**From:** John Shepard <emailjcs@comcast.net>  
**Sent:** Monday, September 28, 2020 12:06 PM  
**To:** citycouncil; CityRecorder  
**Subject:** Testimony for 28 September City Council agenda item 7.2a  
**Attachments:** Amending Salem Revised Code Chapter 70 (Utilities), Chapter 71 (Stormwater), and Chapter 601 (Floodplain Overlay Zone) - Submission A.pdf; Amending Salem Revised Code Chapter 70 (Utilities), Chapter 71 (Stormwater), and Chapter 601 (Floodplain Overlay Zone) - Submission B 24HR Design Storm .pdf

Amending Salem Revised Code Chapters 70 (Utilities), 71 (Stormwater), and 601 (Floodplain Overlay Zone)

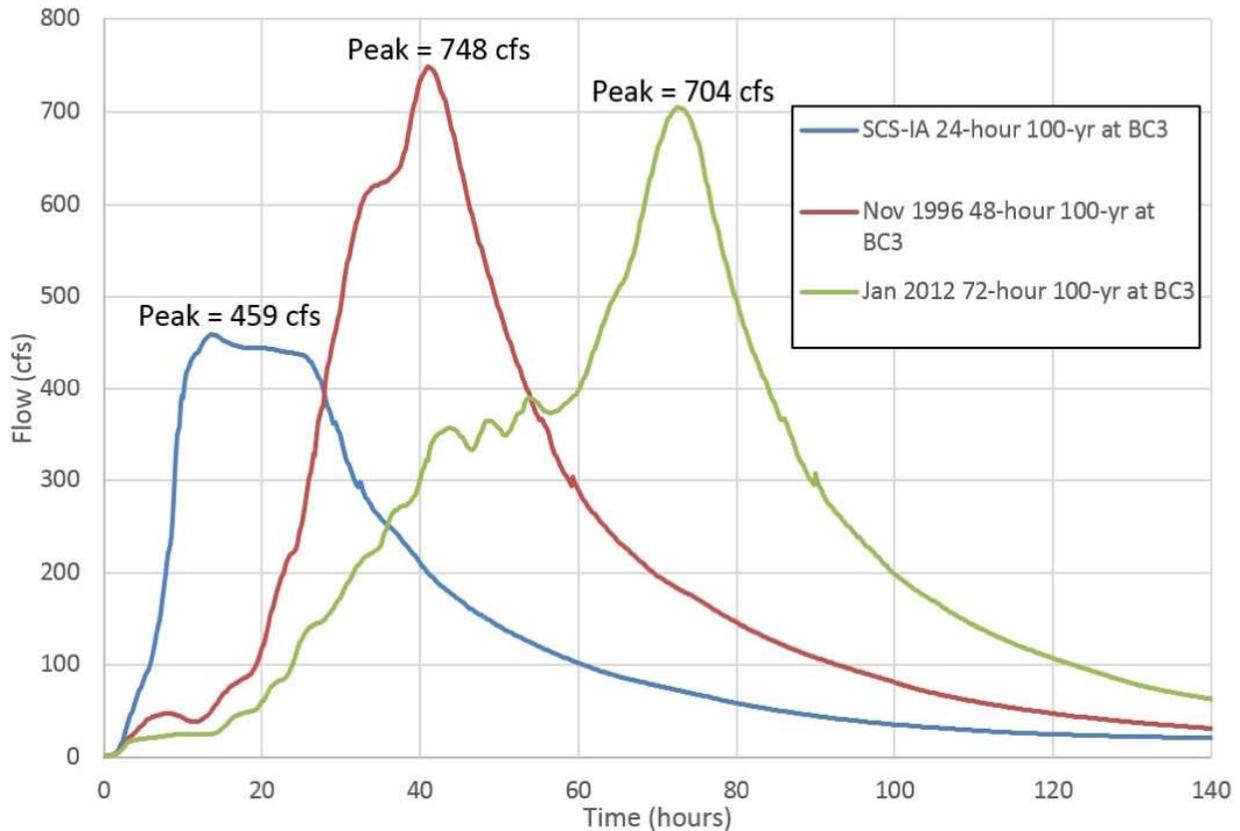
A “synthetic rainfall distribution” has been used in Salem well before the Councils approval of SRC 71. It has been used as a tool to help engineers identify a metric for “synthetic” rainfall and to help calculate the volume of stormwater in a given place for a defined amount of time.

The problem: The 24-hour design storm standard is not the tool to be used in the Pacific NW, nor in Salem Oregon.

Specifically, the results of these Salem studies conclude, the 24-hour Design Storm method failed to adequately identify flood peaks and flow volumes in the Battlecreek Basin.

Salem needs a different metric. With gauges in the creeks and analysis of the impact of “Flow Volume”, a short cut to resolve the complexity is for the City to regulate “Stream Flow Volume”.

Using a “new standard” of “Flow Volume at say 300 cf/s” identifies a specific limit that all parties must adhere. New Projects would need to limit their flow to assure that stormwater runoff would not increase the peak flows beyond the “Flow Volume” limit. Existing flow
